UNITED NUCLEAR
CORPORATION
CHEMICALS DIVISION
FEBRUARY 24, 1964

SUBJECT: SNM-33 AMENDMENT TO INCLUDE SHIPPING CONTAINER BE-1351

THE FOLLOWING IS SUBMITTED IN ACCORDANCE WITH OUR DISCUSSION OF FEBRUARY 20th PERTAINING TO AMENDMENT OF SPECIAL NUCLEAR MATERIAL LICENSE SNM-33 TO INCLUDE OUR SHIPPING CONTAINER IDENTIFIED AS BE PERMIT 1351. PLEASE MAKE THE FOLLOWING CHANGES IN "GENERAL INFORMATION AND PROCEDURES APPLICABLE TO THE HANDLING OF SPECIAL NUCLEAR MATERIAL" AS REVISED THROUGH DECEMBER 15, 1963:

SK-5 REVISED 2/24/64

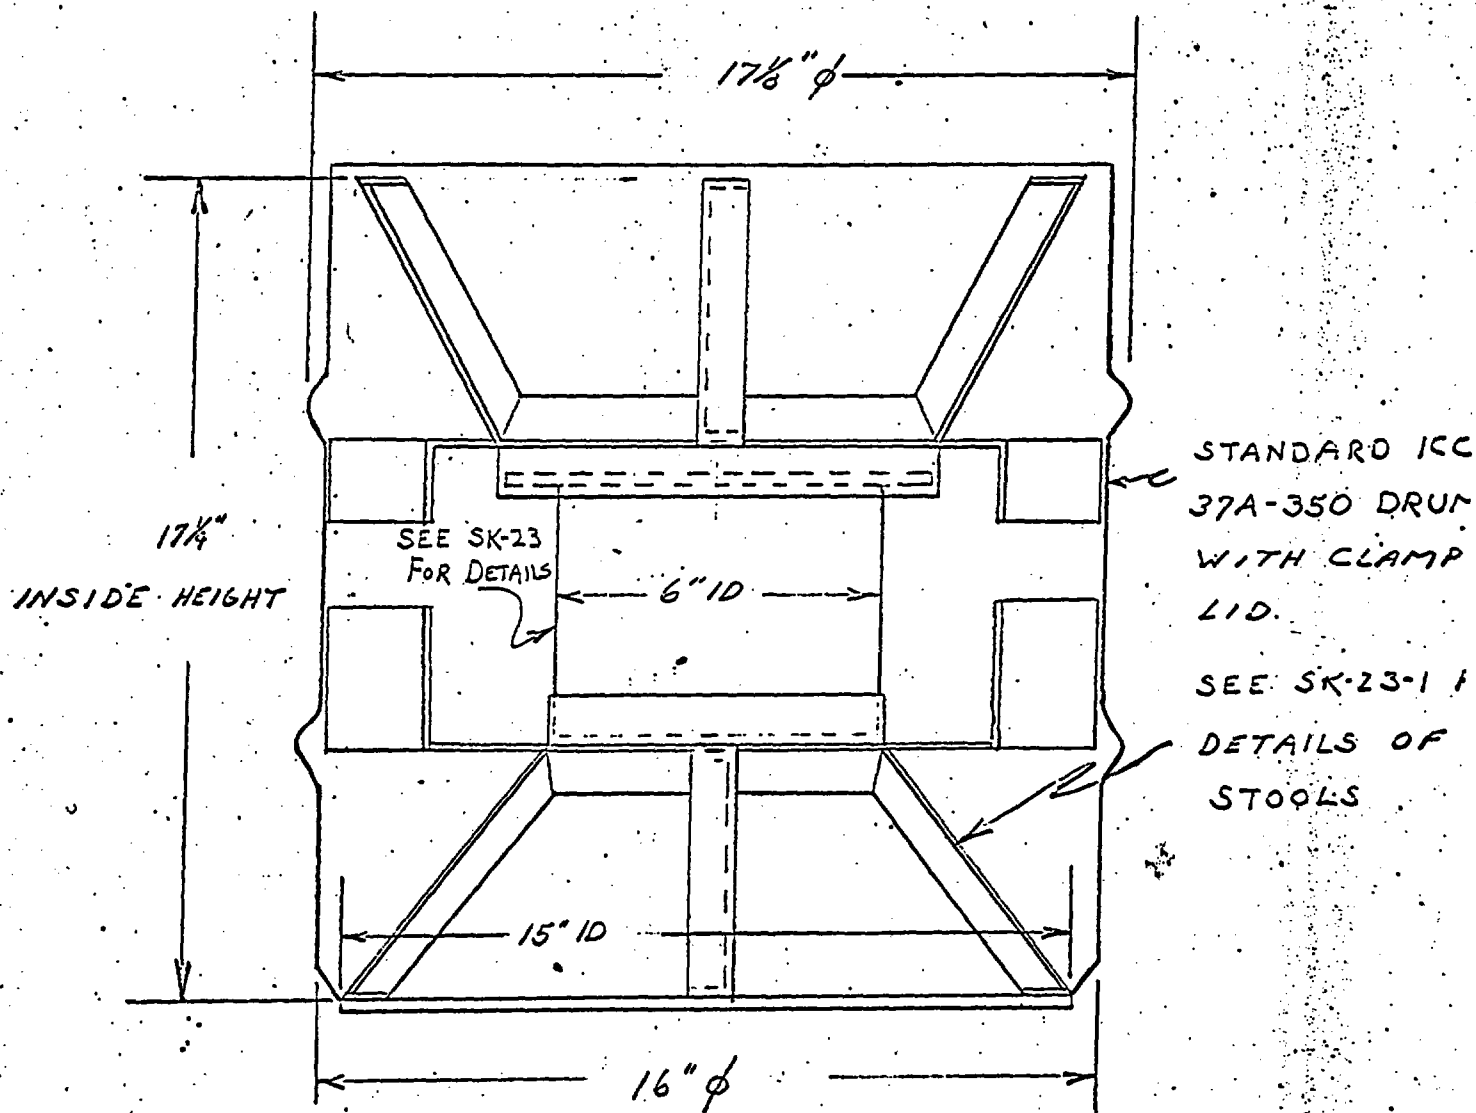
REPLACE SK-5 WITH SK-5, REVISED FEBRUARY 24, 1964

THE ASSEMBLED ARRANGEMENT OF THE CONTAINER IS SHOWN ON SKETCH SK-5 REVISED 2/24 WITH DETAILS OF THE SUPPORTING STOOLS AND INNER POT OR CONTAINER SHOWN ON SKETCHES SK-23 AND SK-23-1, REVISED FEBRUARY 24, 1964.

THE INTERNAL CONSTRUCTION OF THE CONTAINER IS SHOWN ON DRAWING SK-5 REVISED FEBRUARY 24, 1964 AND SK-23-1 REVISED FEBRUARY 24, 1964. THE 15 GALLON DRUM IS A STANDARD ICC TYPE 37-A-350 DRUM FABRICATED FROM 20 GAUGE STEEL. THIS DRUM WAS DROP TESTED FROM A HEIGHT OF 30 FEET. A DROP ON THE END RESULTED IN LESS THAN A FIVE PERCENT CHANGE IN THE SPACING BETWEEN THE BOTTOM OF THE DRUM AND BOTTOM OF THE "POT". A DROP ON THE SIDE RESULTED IN A MAXIMUM REDUCTION OF $1\frac{1}{4}$ " ON THE DIAMETER OF THE DRUM (CORRESPONDING TO A MAXIMUM REDUCTION OF $1\frac{1}{4}$ " IN THE SPACING BETWEEN THE DRUM AND POT ON THE SIDE OF THE IMPACT). THE MINIMUM DRUM DIAMETER IS THEREFORE $14\frac{3}{4}$ ". THE NET VOLUME OF THE DRUM AFTER THE DROP IS THEREFORE 1.7 CUBIC FEET. FROM FIGURE 23 OF TID-7016, REVISION 1, AT LEAST 20 SUCH UNITS IS A SAFE QUANTITY.

PHOTOGRAPHS OF THE DROP TESTS ARE ENCLOSED. (NOTE: THE END DROP WAS MADE WITH A CONTAINER BEFORE THE MODIFICATIONS SHOWN ON THE REVISED SKETCHES SK-5 AND SK-23-1 WERE MADE. THESE MODIFICATIONS WILL NOT EFFECT THE RESULTS OF THE END DROP.) FIVE ADDITIONAL COPIES OF THESE PHOTOGRAPHS WILL BE SENT WITHIN A WEEK.

SHEET NO. _____ OF _____
JOB NO. SK-23-1 REVISED
2/24/69

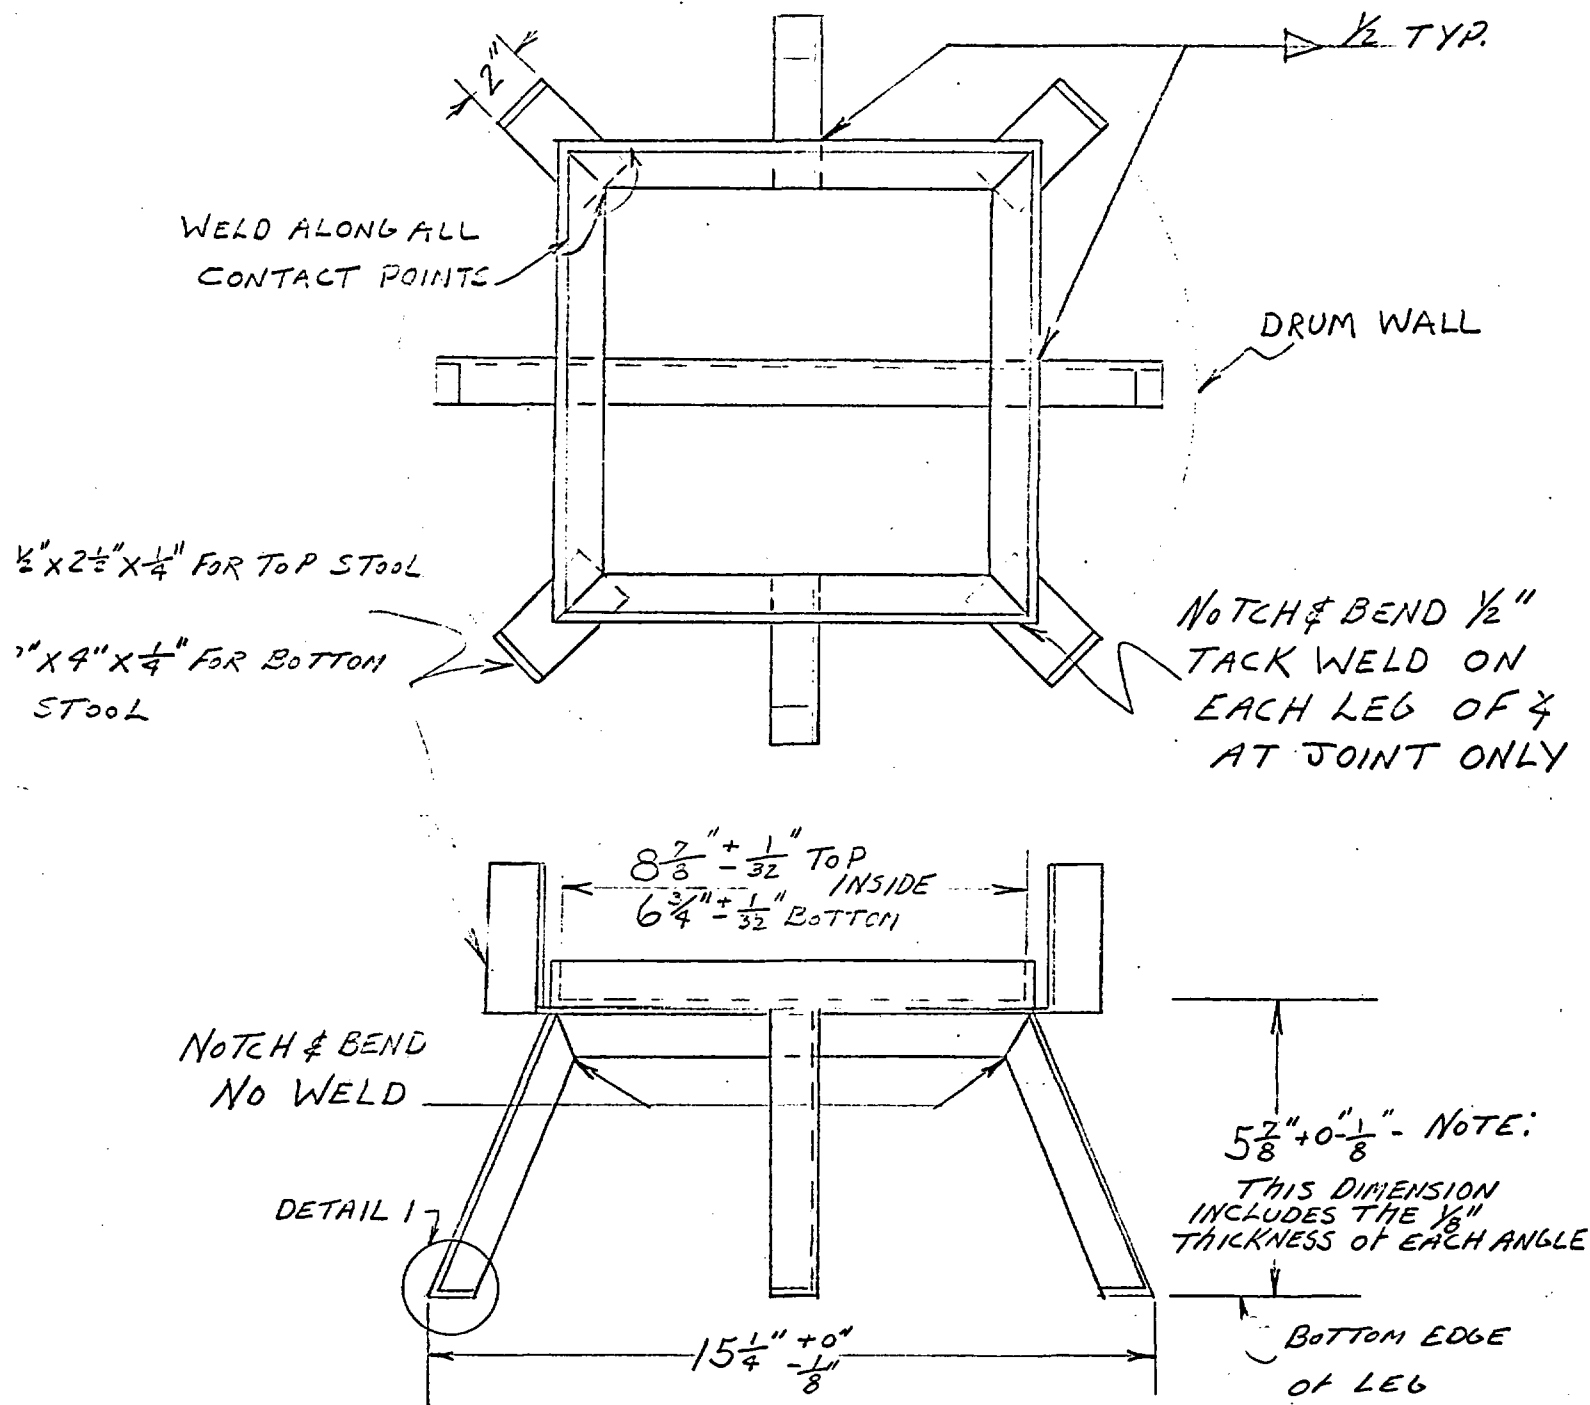
REPLACE SK-23-1 WITH SK-23-1 REVISED FEBRUARY 24, 1964
